REQUEST FOR COUNCIL ACTION

AGENDA SECTION: PUBLIC HEARINGS	ORIGINATING DEPT: PLANNING	ITEM NO. E-2
ITEM DESCRIPTION: General Development Plan #197 by GP Development Inc. to be known as <i>Fieldstone</i> . The Plan incorporates approximately 146 acres of land to be developed with single family detached dwellings. The plan shows the property being served by both private and public roadways and does provide an area for a public park. The property is located along the west side of 18 th Avenue SW, north of the Hart Farm Subdivision and south of Institute Hills.		PREPARED BY: Mitzi A. Baker, Senior Planner

Fieldstone GDP#197

FIELDSTONE
GENERAL DEVELOPMENT PLAN

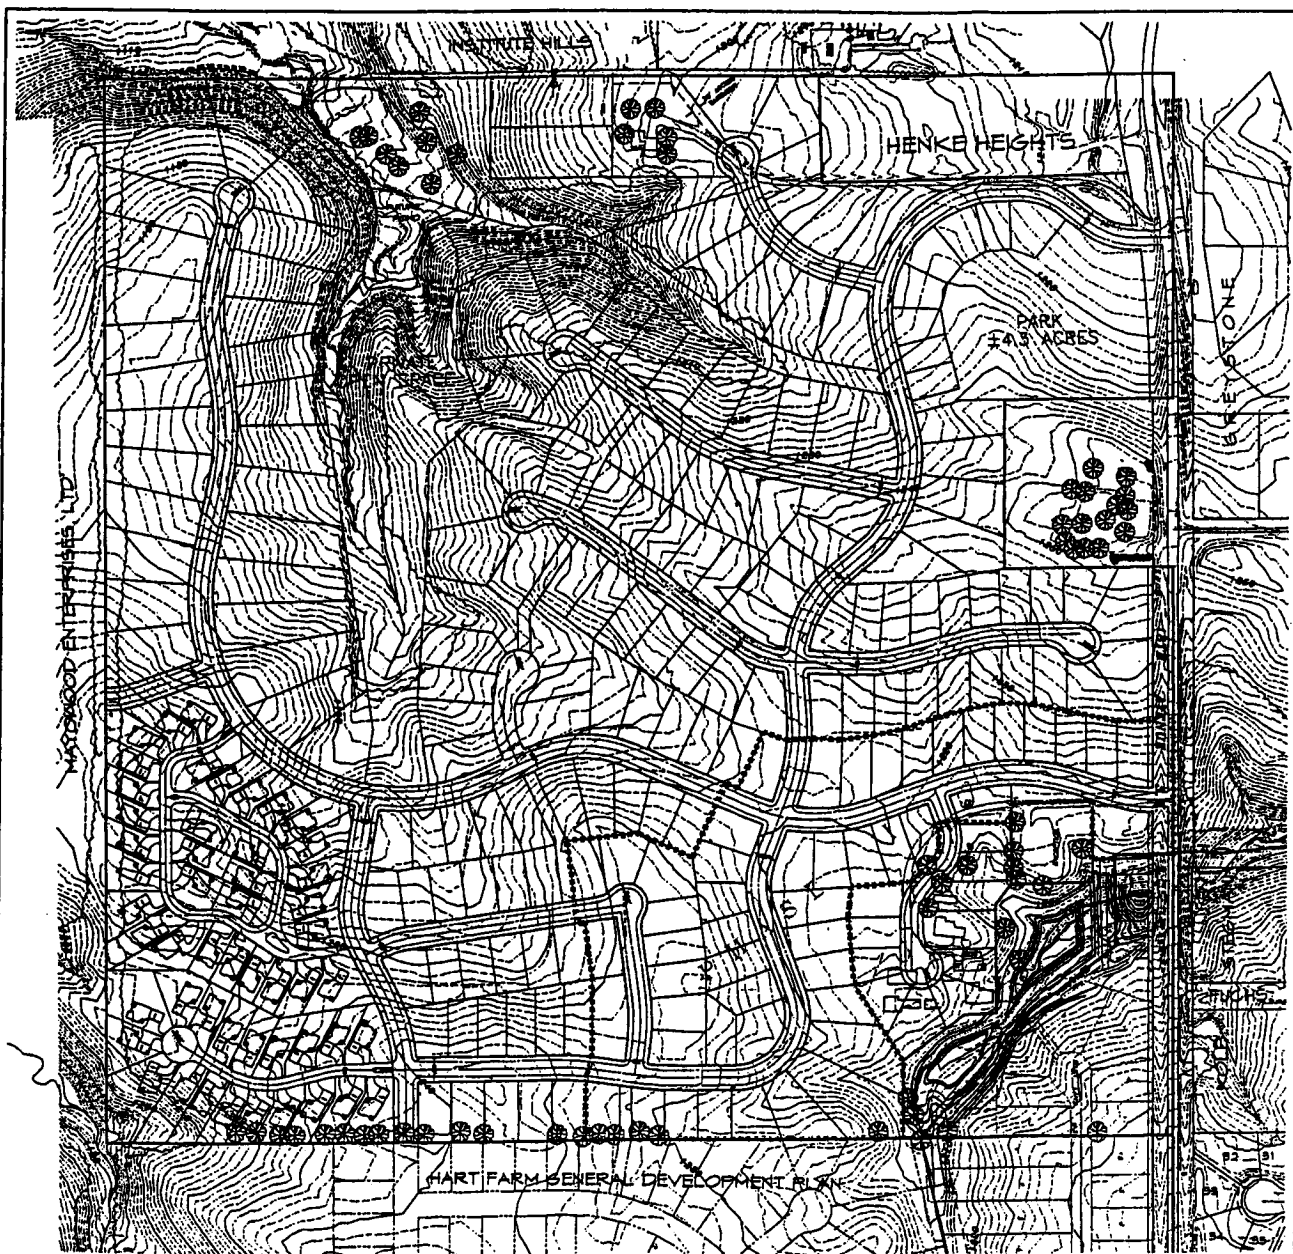
** A REVISED GDP was submitted to the Planning Department on January 23, 2003 to address revisions previously recommended by staff (condition #1) .

At the time the original GDP was submitted and reviewed by staff, staff contacted the consultant to note a concern with the GDP's failure to provide access to an "exception" parcel located in the southeast portion of the property. Upon further consideration Planning recommends that the GDP should be revised to identify public road access to the "exception" parcel. The current roadway alignment results in a residual sliver of land located between the public road and the "exception" parcel. Additionally, the residual parcel does not appear to meet minimum standards for a single family lot. The GDP should be designed to allow for orderly growth and development, and to permit future subdivision of adjacent parcels.

- a) ~~identify the proposed stormwater pond in the NW portion of the property~~
- b) ~~clarify the ownership of the future private open space by labeling it as "Private Open Space"~~

- c) ~~show private roads @ 28' width~~
- d) provide public road access to the exception parcels located north of the existing pond, in the southeast portion of the Development; and to eliminate the residual parcel located between the roadway and "exception" parcel by incorporating a portion of it into the adjacent single family parcel or by realigning the roadway such that it is eliminated entirely.

- e) ~~minimize the number of cul-de-sac roads by eliminating at least two cul-de-sacs~~
- f) ~~provide an additional mid-bloc connection between the two cul-de-sac's located east of the open space and north of the east/west roadway connecting to 18th Ave. SW, OR connect the two cul-de-sacs to provide a through public road~~

- g) ~~the throat length of any cul-de-sac shall be a minimum of 50 feet in length.~~
